COMMISSION VOTING RECORD

DECISION ITEM: SECY-12-0034

TITLE: PROPOSED RULEMAKING - 10 CFR 50.46C: EMERGENCY
CORE COOLING SYSTEM PERFORMANCE DURING
LOSS-OF-COOLANT ACCIDENTS (RIN 3150-AH42)

FIGURE 1: Measured Offset Strains

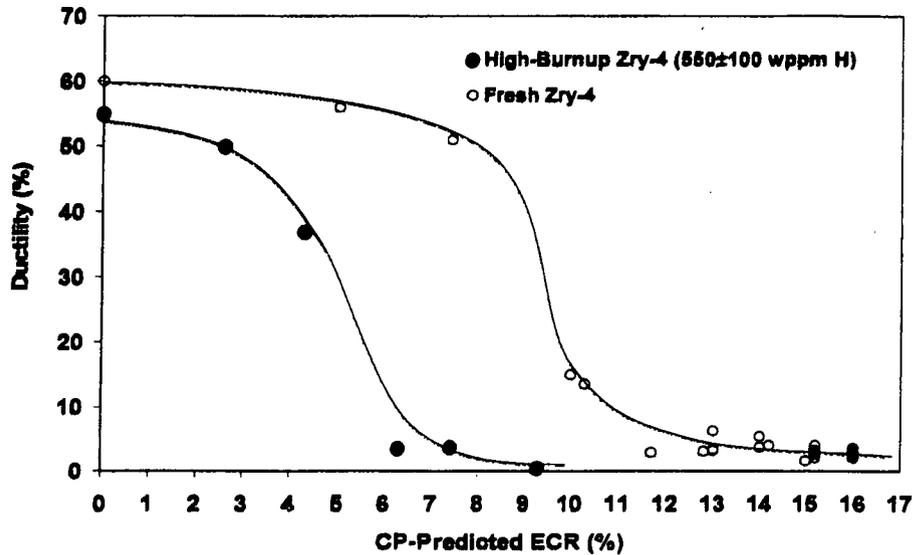
[The staff should provide one or two summary sentences that explain the phenomenon depicted in Figure 1.]
